Department of Environmental Quality

Subject: January 2010 Inspection Report, Cameco Resources, Permits 603 and 633

JANUARY 2010 INSPECTION REPORT DISTRICT 1/LAND QUALITY DIVISION

COMPANY: Cameco Resources (CR), Highland Ranch, Permit #603
& Smith Ranch, Permit 633

Figure 1 Cutting tool used to open poly pipe production zones where screen will be installed.

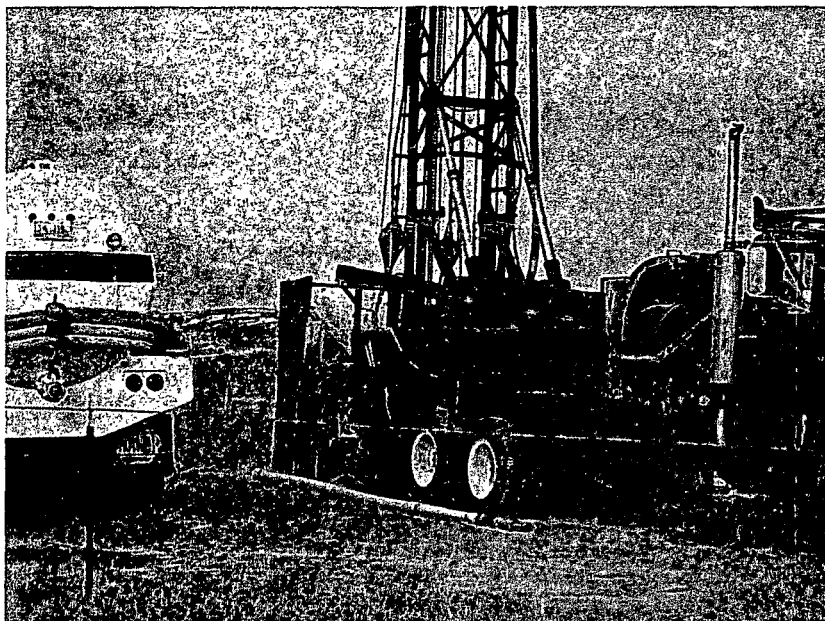
The inspectors observed partial completion activities in Wellfield 15A. Under-reaming was completed at the first drill site observed. The driller was running casing and placing spacers at 40 feet intervals. The next step for this well is cementing the hole around the pipe, followed by running a cutter into the pipe to open up the production zone followed by installation of the screen. A cutter tool was observed (**Figure 1**). A second drill site was on lunch break with the screen/packer ready to be installed (**Figure 2**).
